MAPA Meeting - May 5, 2021  
Recent and Upcoming Policy Changes

**5. Revisions to Section 604.40.3.1 to include box culverts; Std. Plan 604.40 to remove Type B collars; bid items to remove Type B collars (see standard plans at the end of this document). Effective July 1, 2021**

**6. New Std. Plan 616.20 for temporary traffic control of two-lane two-way roadways; currently identified for CLC and Seal Coat type projects (see standard plans at the end of this document). Pending comments from FHWA will be effective July 1, 2021.**

<b>MISSOURI HIGHWAYS AND TRANSPORTATION COMMISSION</b> 105 WEST CAPITOL JEFFERSON CITY, MO 65102 1-888-ASK-MODOT (1-888-275-6636)	
		<b>PIPE COLLARS</b> <b>Type A</b>	
DATE EFFECTIVE:	10/01/2000	<b>604.40F</b>	SHEET NO.
DATE PREPARED:	8/21/2009		1 OF 2

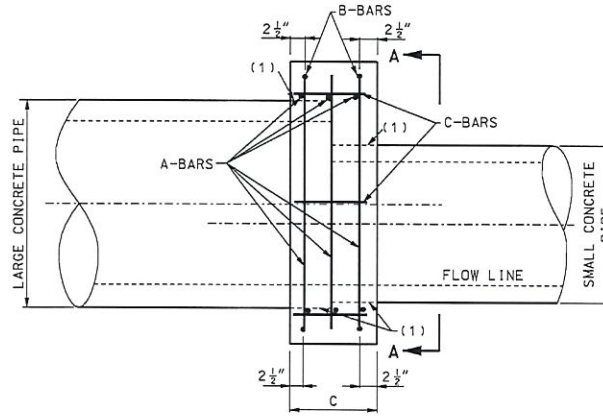
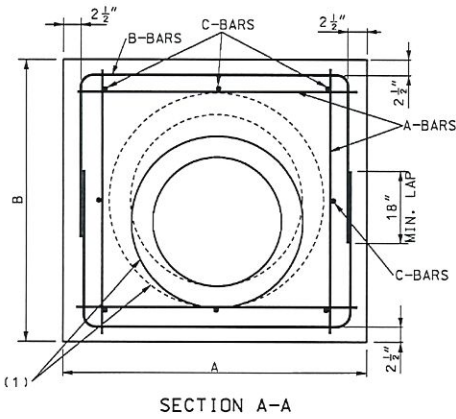
Move to sheet 2 of 2

Leave here and copy this note on sheet 2.

General Note:  
For pipe extensions that are 5 feet in length or shorter, a smooth tapered sleeve may be used in lieu of a Type A Collar, if approved by the engineer. See Smooth Tapered Sleeve Detail in Standard Plan 732.00.

<b>MISSOURI HIGHWAYS AND TRANSPORTATION COMMISSION</b> 105 WEST CAPITOL JEFFERSON CITY, MO 65102 1-888-ASK-MDDOT (1-888-275-6636)	
		<b>PIPE COLLARS</b> Type C
DATE EFFECTIVE: 10/01/2000 DATE PREPARED: 8/21/2009	<b>604.40F</b>	SHEET NO. <b>2 OF 2</b>

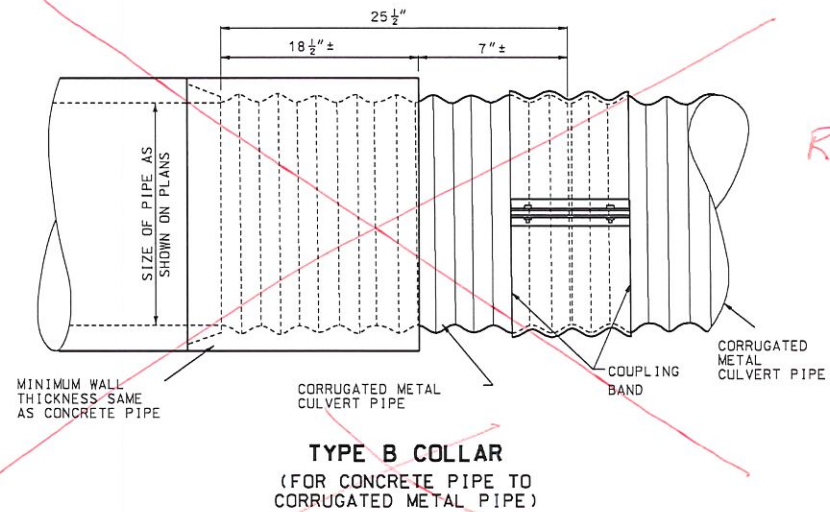
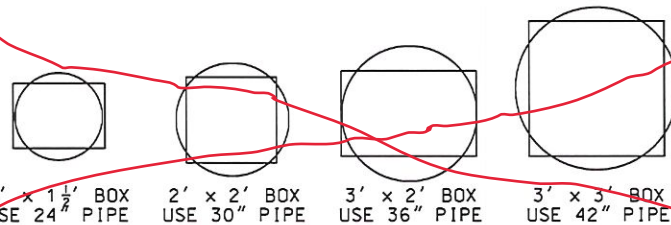
Move this table to sheet 1 of 2.

Add Bending Diagram for B-Bars from sheet 1.

Remove this detail.
